6. Memorandum prepared by Lawrence Engineering dated November 7, 2004, regarding Bar Boot Ranch – Investigation of Structures, together with attachments.

8. June 20, 2006, correspondence from J. Darrell Jordan, Manager of the ADWR Office of Water Engineering, regarding Gate Tank (02.08) and Crow Tank (02.09) Dams, May 10, 2006 Inspection Reports with enclosures.

9. February 16, 2007, Notice of Violation, received from the Arizona Department of Water Services (“ADWR”).
10. February 28, 2007, correspondence from William R. Radke, Refuge Manager, United States Department of the Interior Fish and Wildlife Service, together with enclosures.

Scope of Work Bar Boot Ranch Dam Investigation

Gate Tank Dam
Bar Boot Ranch
Investigation of Structures

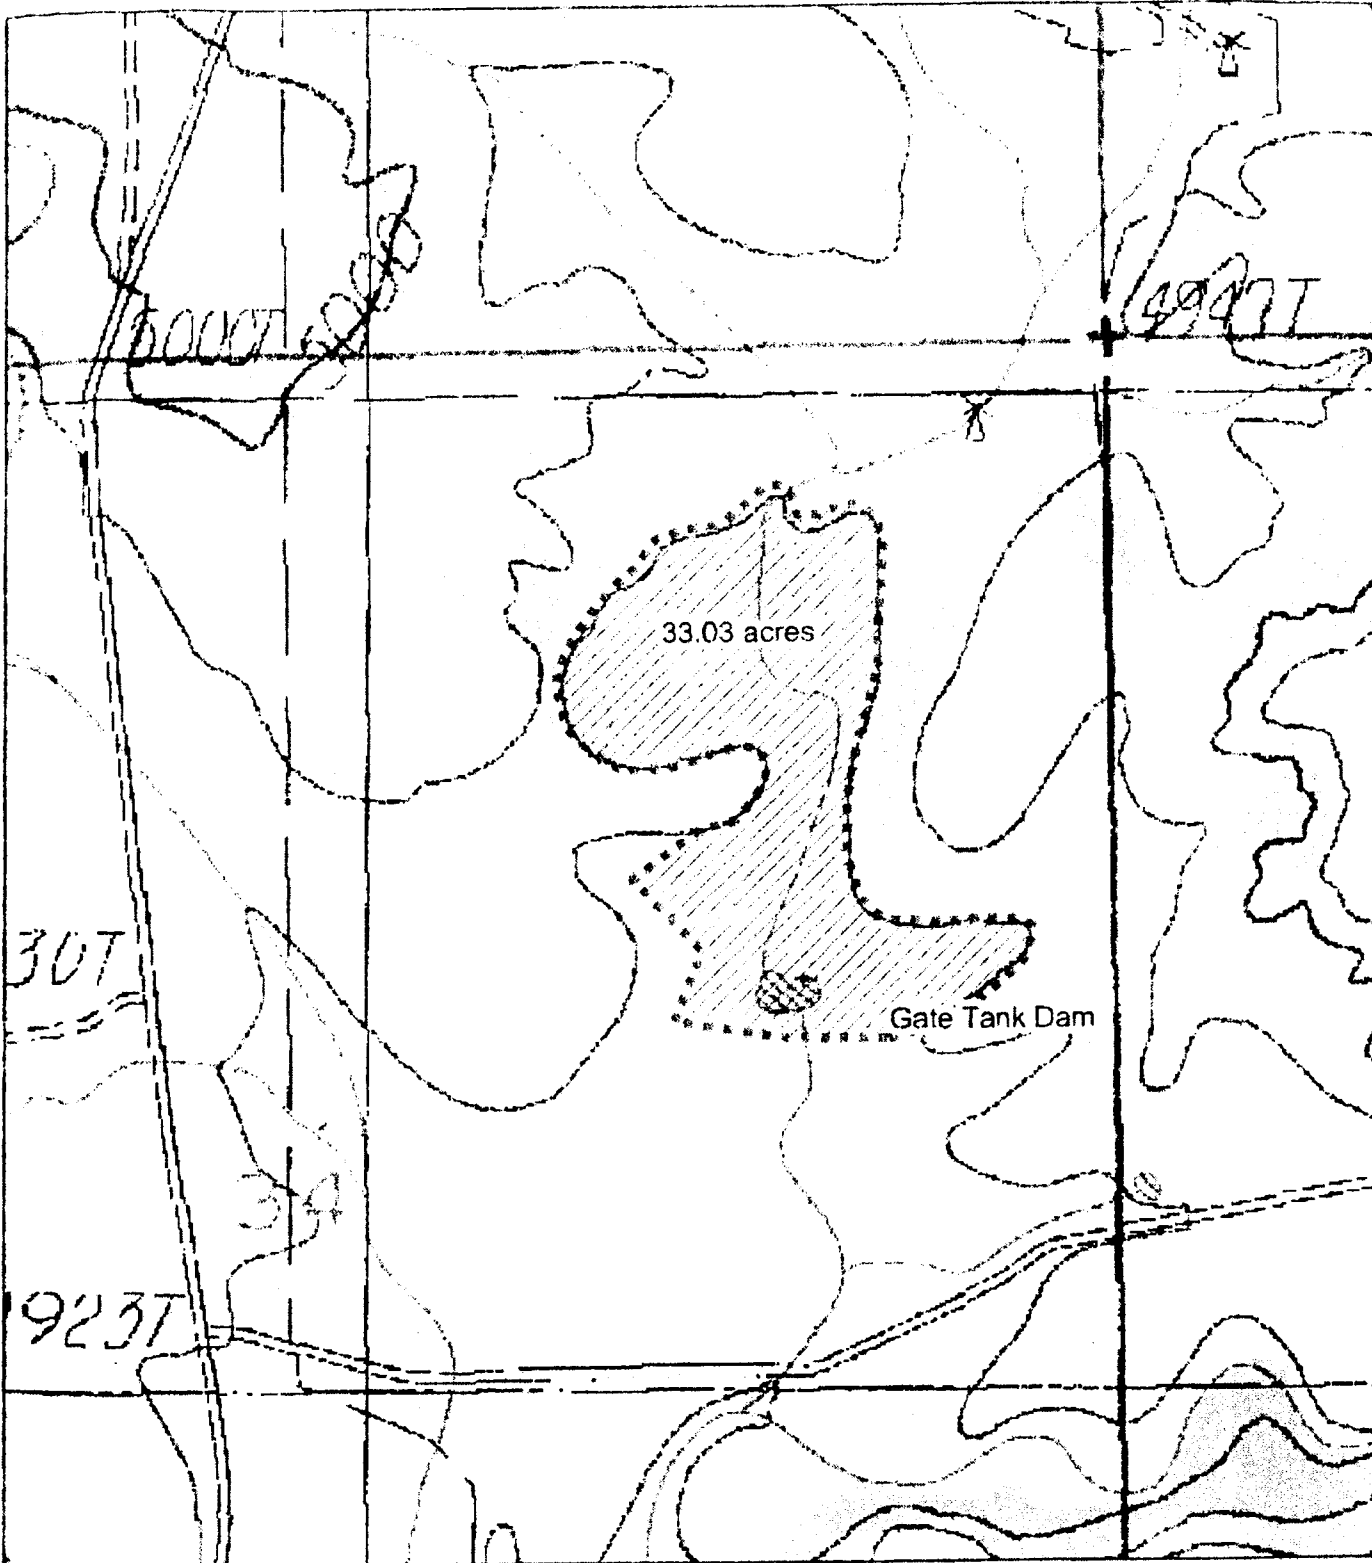
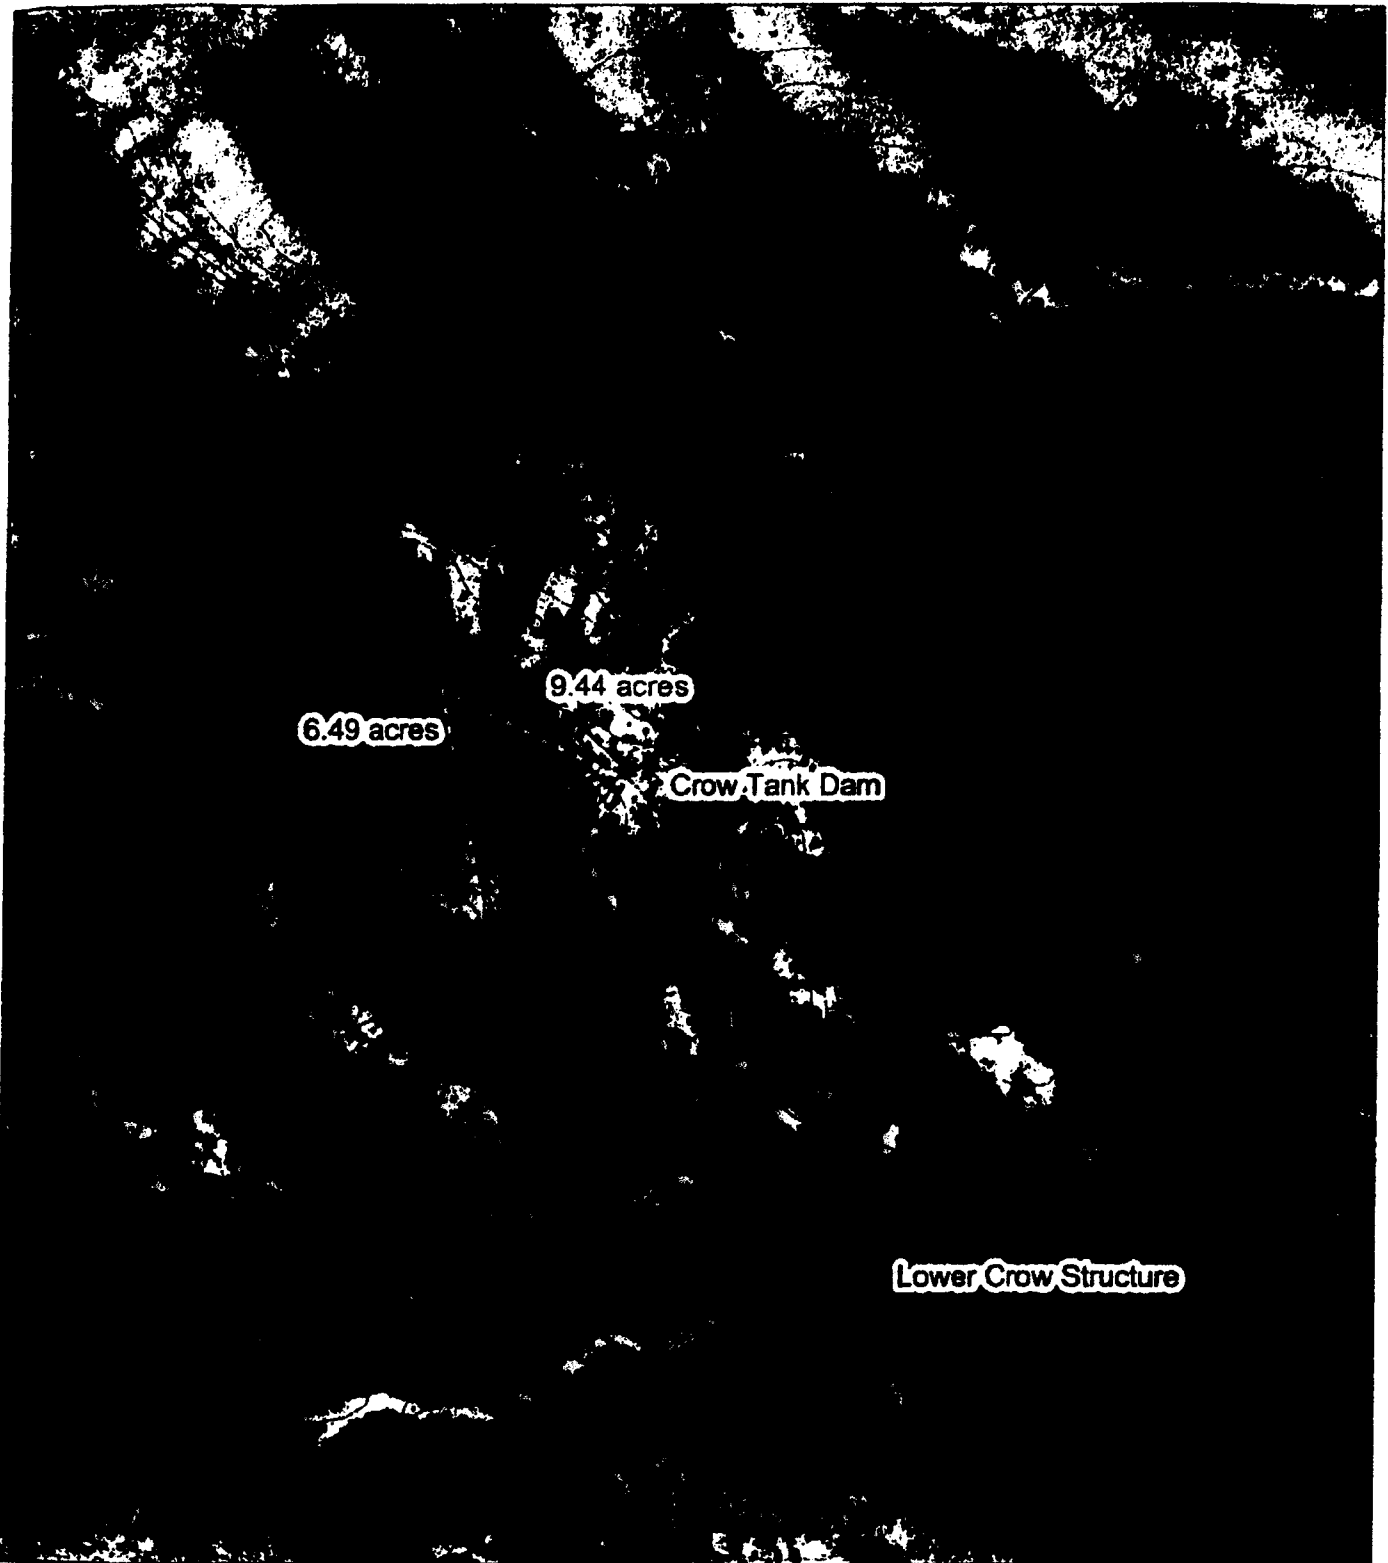
This dam is a recent "repair" of a smaller historic structure at this location. 1992 aerial photos show a much smaller structure. The old stream channel is about 7.5 feet below the rest of the area. The embankment was pushed up from the reservoir and slopes are generally 2:1 downstream and 3:1 upstream. The owner indicated that there was no foundation treatment and no moisture added to the soil during "compaction." The crest is about 20 feet wide. The dam is 22.8 feet high from the low point in the historic channel to the spillway elevation. The surface area of the reservoir is about 33 acres. The storage depth at the upstream toe is approximately 12 feet. Using $1/3 H \times A$, the storage capacity is 132 acre feet. This dam is large enough to be within ADWR Dam Safety jurisdiction as defined by ARS § 45-1201. Construction of a jurisdictional dam without ADWR approval is a violation of ARS § 45-1202A. ARS § 45-1217 outlines the procedures the Department may take. The owner must reduce the size of the dam (storage capacity) or register it with ADWR.

The easiest solution would be for the owner to lower the spillway to an elevation 24 ft. above the lowest point at the downstream toe. We believe this would result in a reservoir storage capacity of less than 50 acre feet. This action would remove the structure from State Dam Safety Jurisdiction.
